RE: Comments of the Large-scale Solar Association on 2018-2019 TPP Preliminary Policy Results and Economic Study Update.

LSA appreciates this opportunity to comment on the CAISO 2018-2019 Transmission Plan Preliminary Policy Results and Economic Study Update of November 16, 2018. These comments are based on the slides and presentations prepared for the November 16 TPP stakeholder meeting.

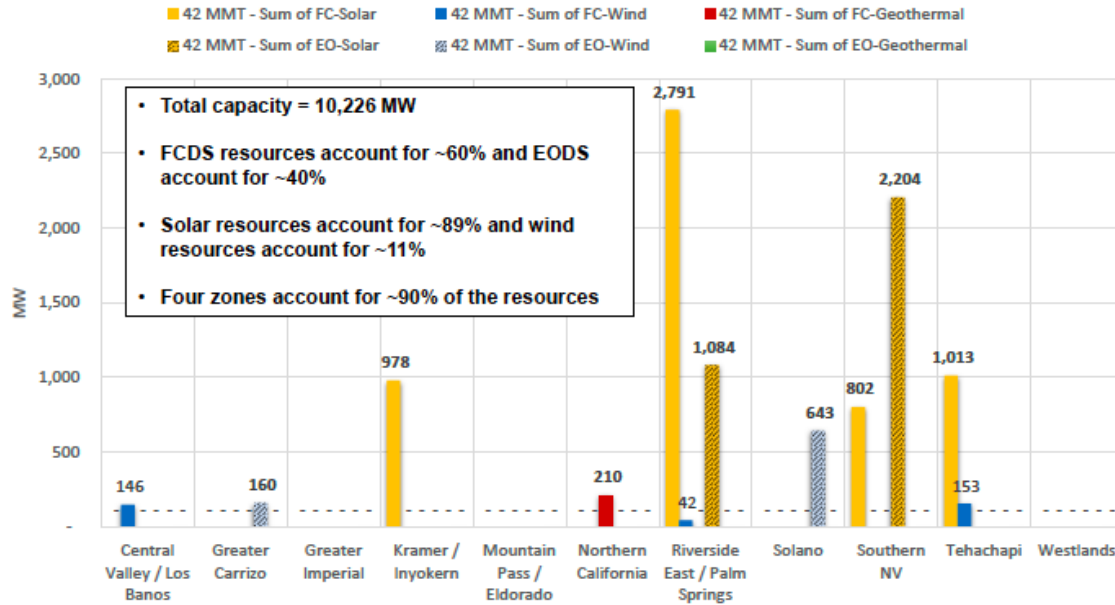
LSA is unclear why the CAISO does not consider the IRP Reference System Plan as the “base portfolio” and recommends it treat this as the base portfolio rather than a sensitivity. As the Reference System plan, this is the CPUC “base case”. LSA understands that the point of CAISO using the CPUC IRP portfolio in the TPP process is to have greater coordination between resource procurement and transmission planning, and not using the Reference System Plan as the base portfolio undermines the goal and the process.

The TPP Default Portfolio includes 3,487 MW of new variable resources added by 2030, and the 42 MMT sensitivity portfolio includes 10,266 MW of new resources. In both cases CAISO assumes that 40% of the solar resources will be EODS. Per the reliability assessment discussed on the November 16 call, no additional transmission is needed since EODS resources are not required for reliability. This however, understates the need for transmission for these resources. While the EODS resources do not require new transmission for capacity delivery, it is highly likely that without new transmission there will be substantial curtailments due to transmission constraints. Most of the new EODS resources are located in areas of Southern California that already face critical transmission constraints and, indicated on the CAISO chart below, the addition of these resources without new transmission will only exacerbate this.
